LETTER AND RESTORATION ADVISORY BOARD (RAB) COMMENTS REGARDING WORK  
PLAN FOR REMOVAL ACTION MUNITIONS RESPONSE SITE 2 FIRE TRAINING AREA  
NWIRP CALVERTON NY  
3/8/2012  
RESTORATION ADVISORY BOARD (RAB)

**Subject:** Review of Work Plan for Munitions Response Site 2  
(Fire Training Area), Removal Action and Munitions Response

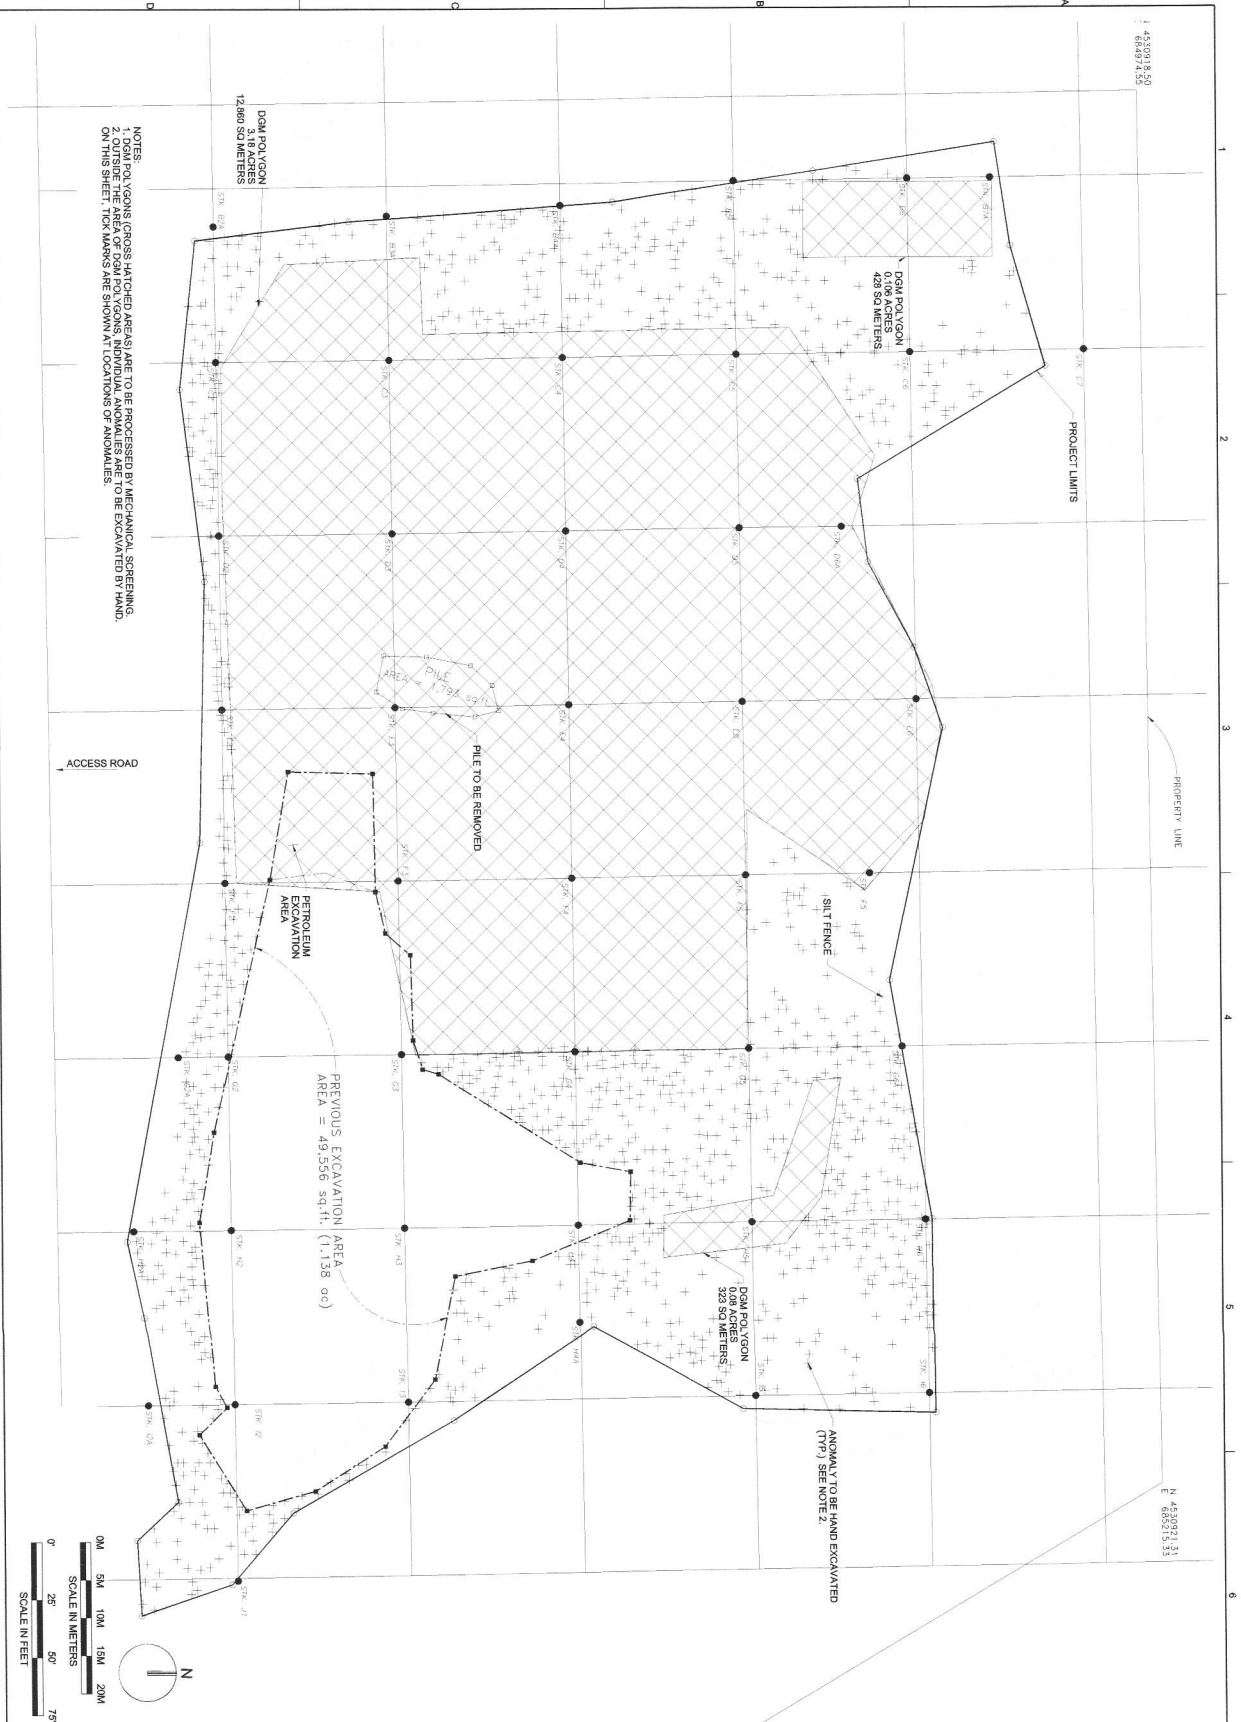
- This project is more complex, and potentially important, than I expected. I did not realize the extent of the (probable) munitions-debris contaminated area until I saw the Work Plan (Figures 2-2 and Appendix E DGM survey mapping results). The munitions excavation areas appear to equal more than five times the previous petroleum-soil removal area. Manual excavation and removal of munitions debris will be done over a large area as well (Figure 4-4).
